AMENDED STAFF REPORT 3/25/82
CITY PLANNING COMMISSION
915 "I" STREET - SACRAMENTO, CALIFORNIA 95814

APPLICATION: 1. Environmental Determination
2. Tentative Map

PROPOSAL: The applicant is requesting the necessary entitlements to divide 14+ acres into 47 single family lots and one parkway lot to be known as River Oaks Ranch.

TENTATIVE MAP
RIVER OAKS RANCH
 UNIT NO. 3
 A.P.N. 31-200-27

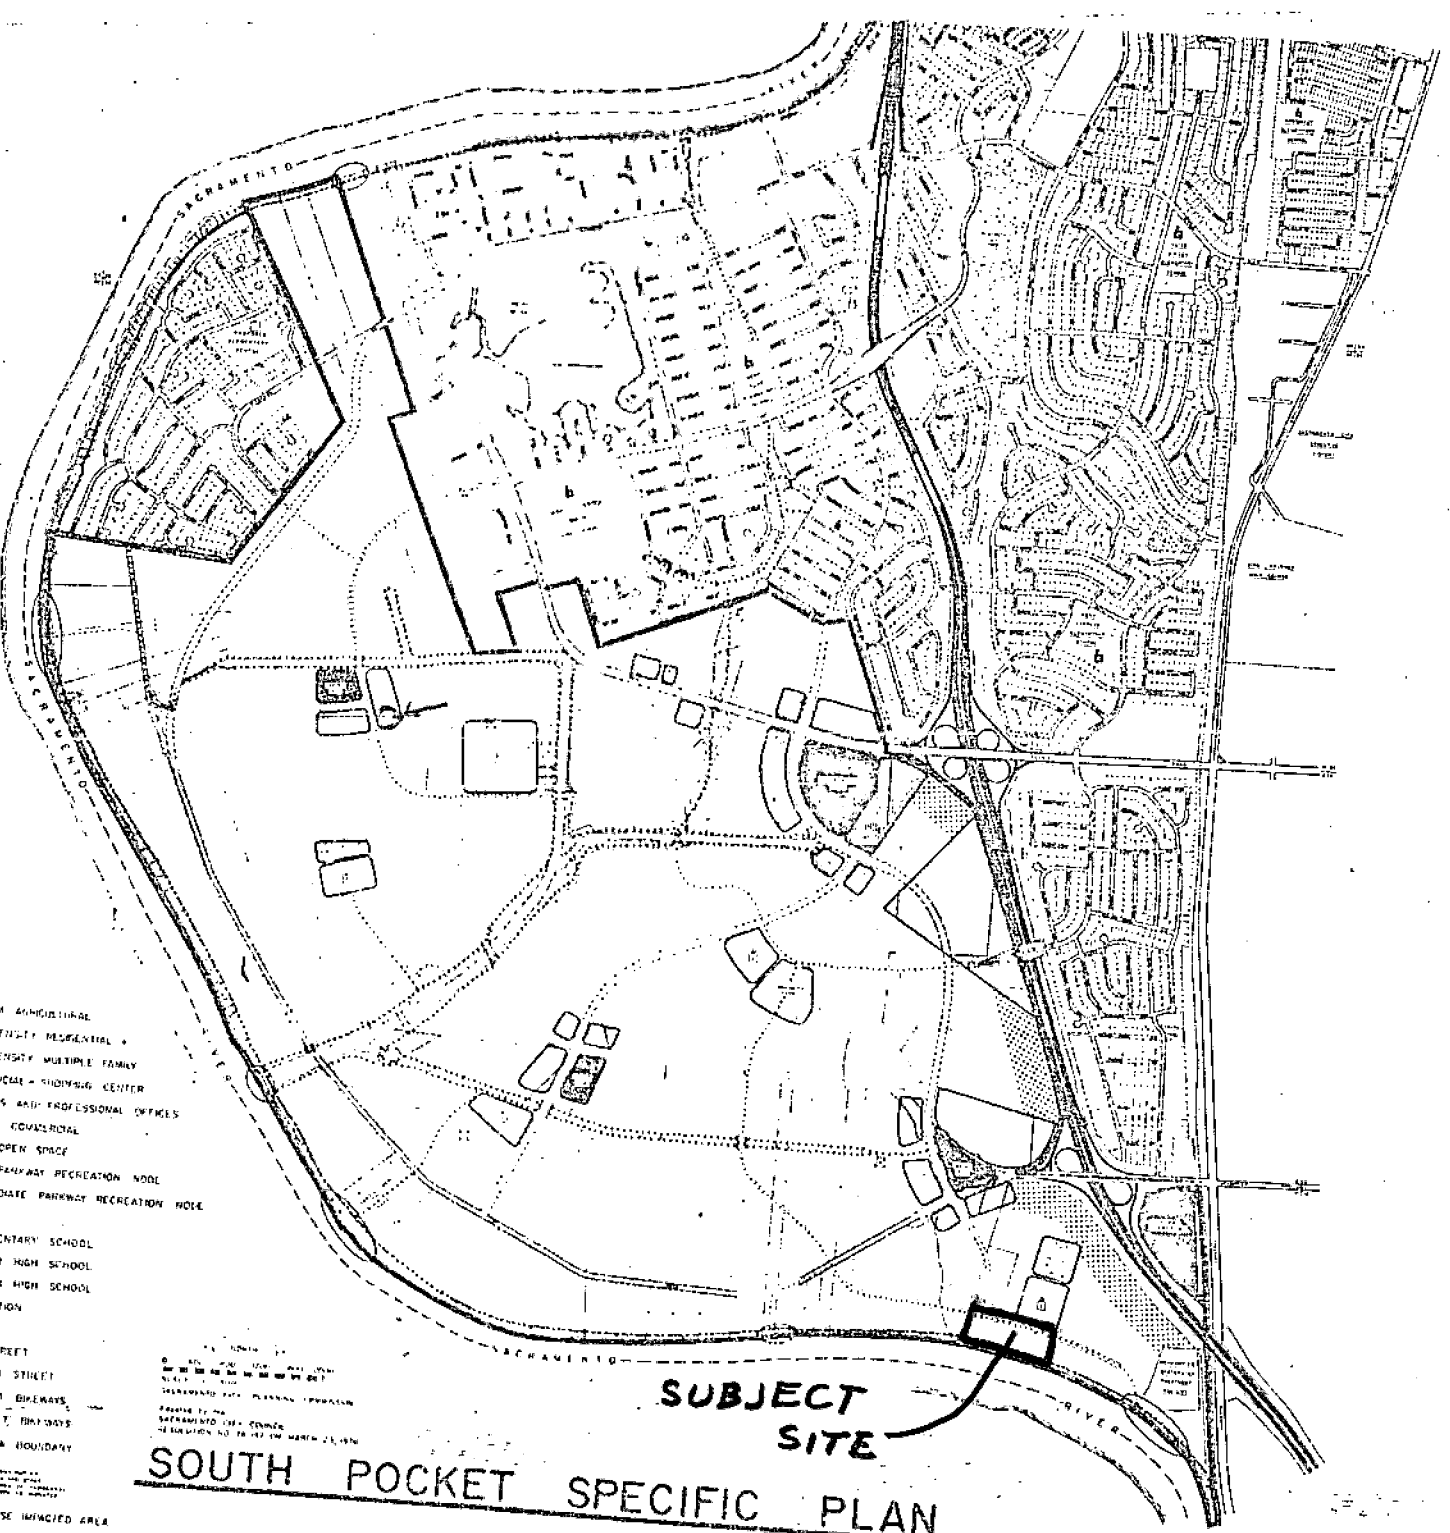
See Lots 26, 27, 5 PUE P&S MUD
6, 47, 5 PUE

002068: 2. Smud will require a 5 foot PUE adjacent to Lots 26 & 27 and to the South of Lots 6 & 47 9/81

EXHIBIT 'A'

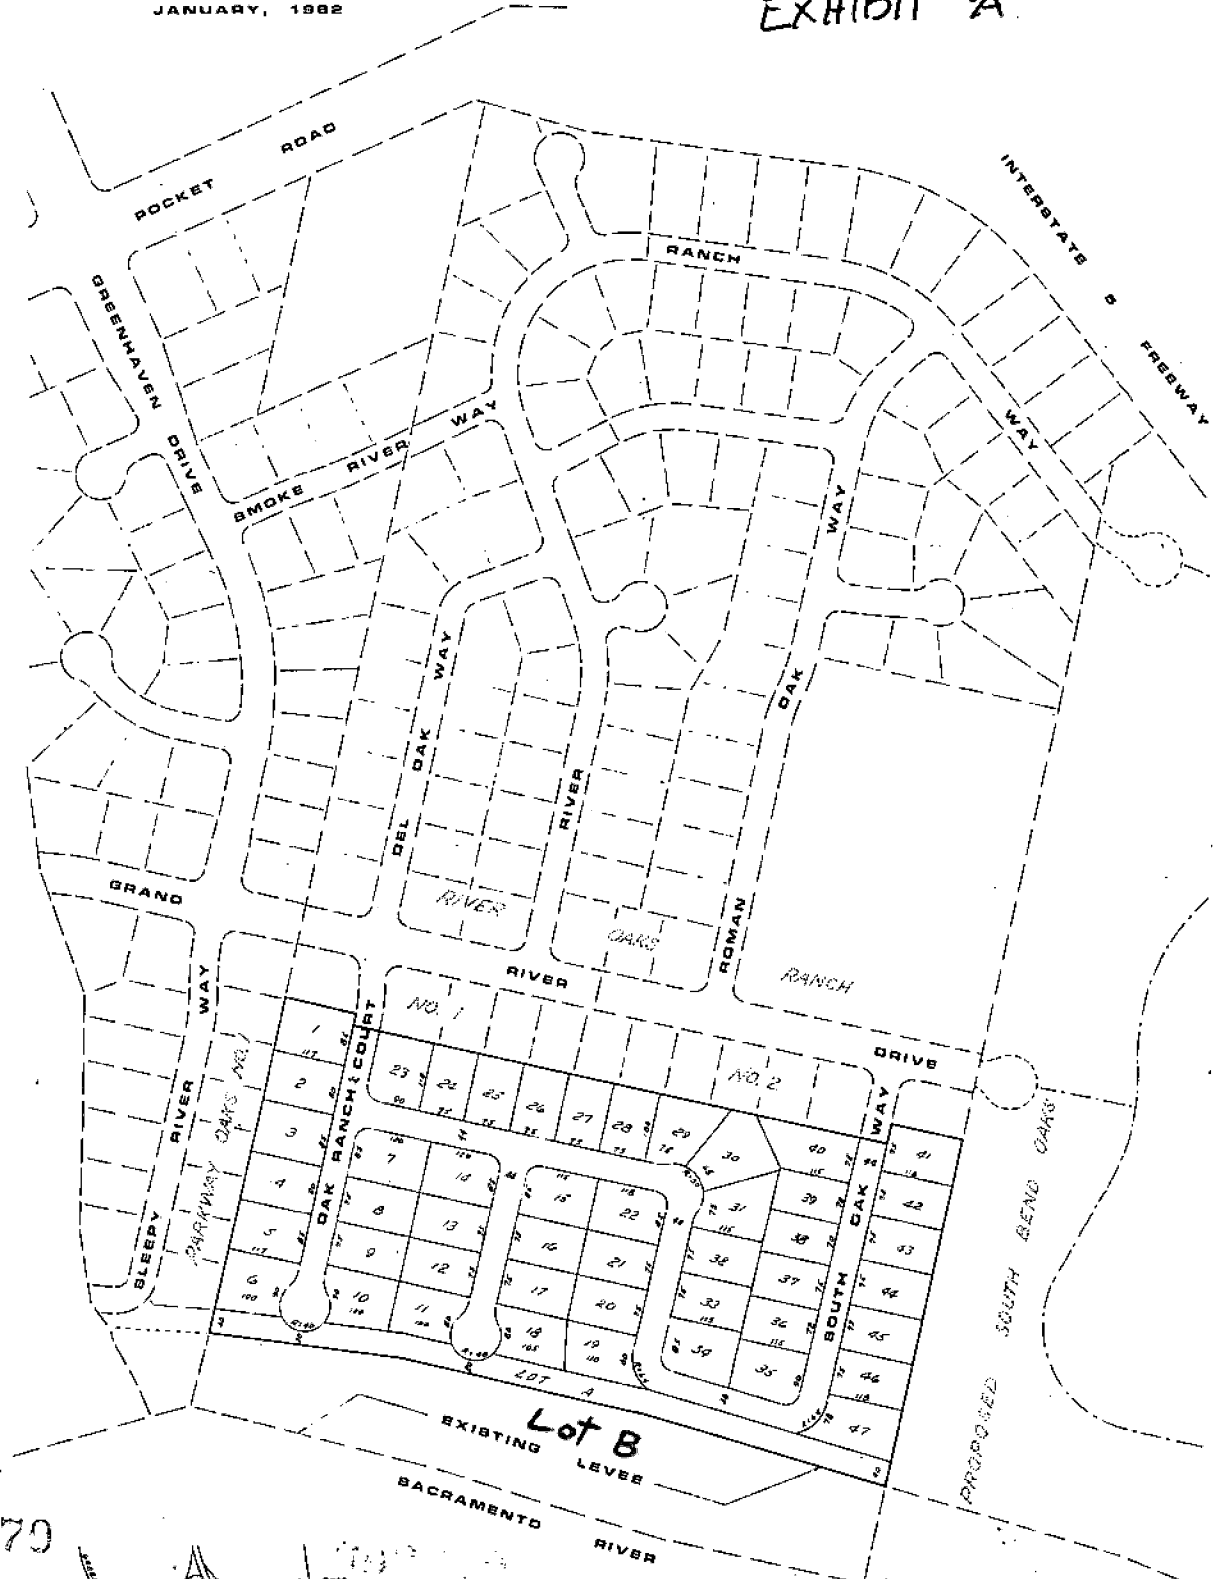
1. The tentative map, as submitted by the applicant, achieves only a 17% north/south lot orientation, which is significantly less than the 80% north/south lot orientation as required by the General Plan. Staff finds that the tentative map can be revised to achieve a 69% north/south lot orientation as shown in Exhibit B. This revision retains the same number of lots and provides for better access to the Sacramento Parkway as well as for better police protection. The applicant has indicated that he opposes the redesign as suggested by staff. The revised map as suggested by staff is 11% less than the required north/south lot orientation. Therefore, to meet the full intent of the General Plan policy, staff requests that the applicant designate five of the remaining east/west oriented lots for Planning Department review of building permits to insure north/south structure orientation. A note shall be placed on the final map referencing this requirement.

6. Prior to City Council consideration the tentative map shall be revised in accordance with Exhibit A which increases the North/South Lot orientation to 70%.

- a/. Prior to City Council consideration the tentative map shall be reviewed in accordance with Exhibit A which relates to the north/south lot boundary to PD#.
- b/. The applicant shall submit a map designating at least five lots showing a structural footprint, including information and potential shading of adjacent lots. Said plan shall be reviewed and approved by the Planning Director prior to final map recordation;
- c/. The above-mentioned five lots shall be designated on the final map. A note shall be placed on the final map indicating the building permit must be received from the Planning Department reviewed and approved.
